Office Action Summary

10/019,556

GOTTE, JOHANNES

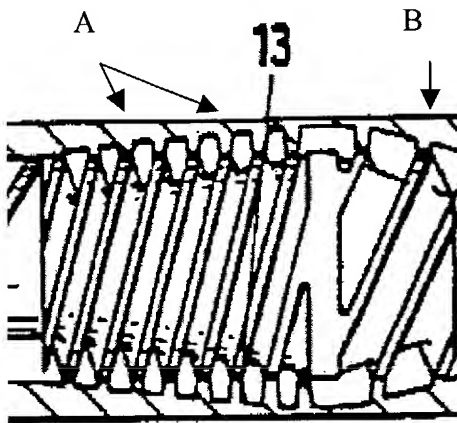
Capelle teaches the claimed apparatus having an extruder with an inlet (3), outlet bore (4), jacket (2), spindle (6), plasticizing zone (13), the jacket thread and the

spindle thread cross section change linearly (A) and (B) in the zone in a complementary manners. See Figure Below.

In regards to claim 3, this feature of the 10-20% and 80-90% of the free total cross sections appears to be taught at point (B). While, the drawings may not be considered as exact scale, the general progression of the threads cross section and dimensions give a general idea that the inlet to outlet cross sections changes.
